Report on the Edgewater  
to  
The City of Madison Plan Commission

The Mansion Hill Steering Committee on the Edgewater  
February 4, 2010

RE: Edgewater

Wisconsin Avenue Facade Comparison @ 1" = 30'  
 The Masonic Temple - Quisling Towers  
 December 9, 2009

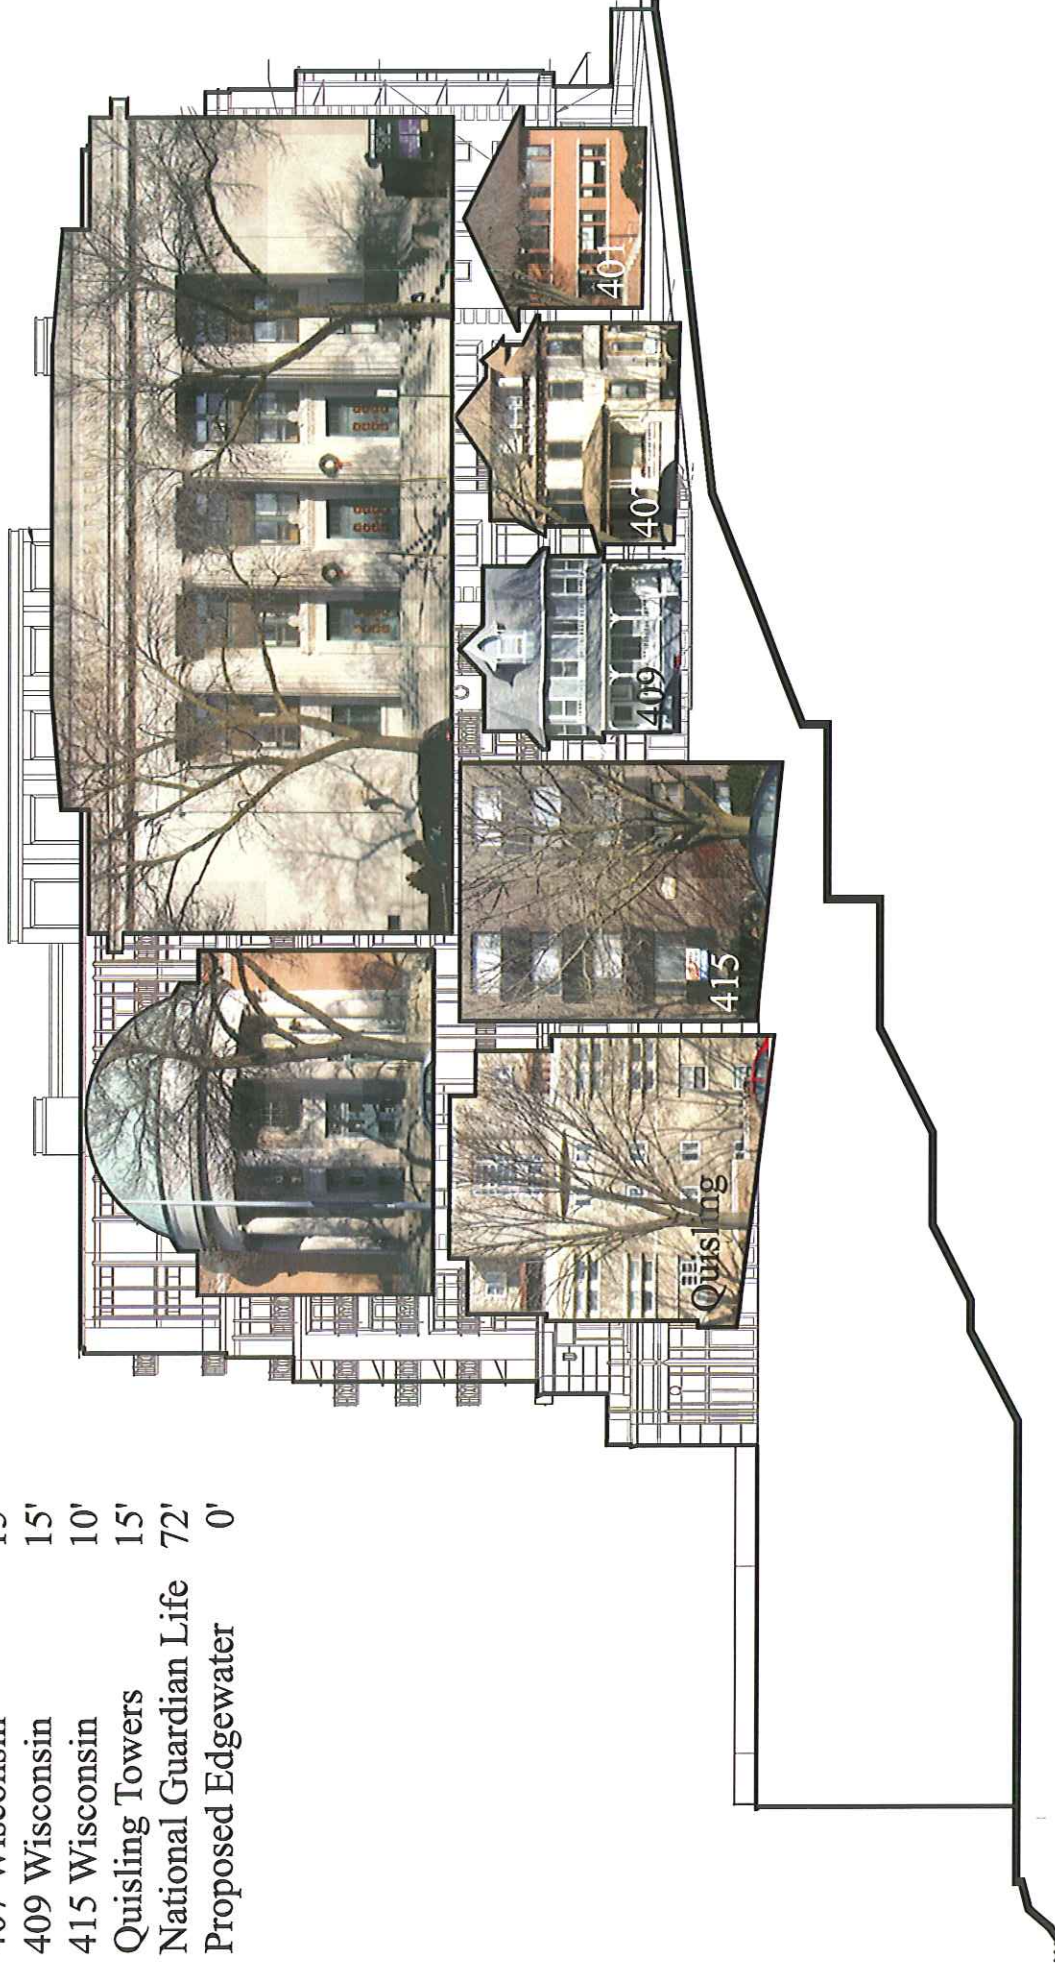
The Masonic Temple	18'
Christ Scientist	15'
401 Wisconsin	8'
407 Wisconsin	15'
409 Wisconsin	15'
415 Wisconsin	10'
Quisling Towers	15'
National Guardian Life	72'
Proposed Edgewater	0'
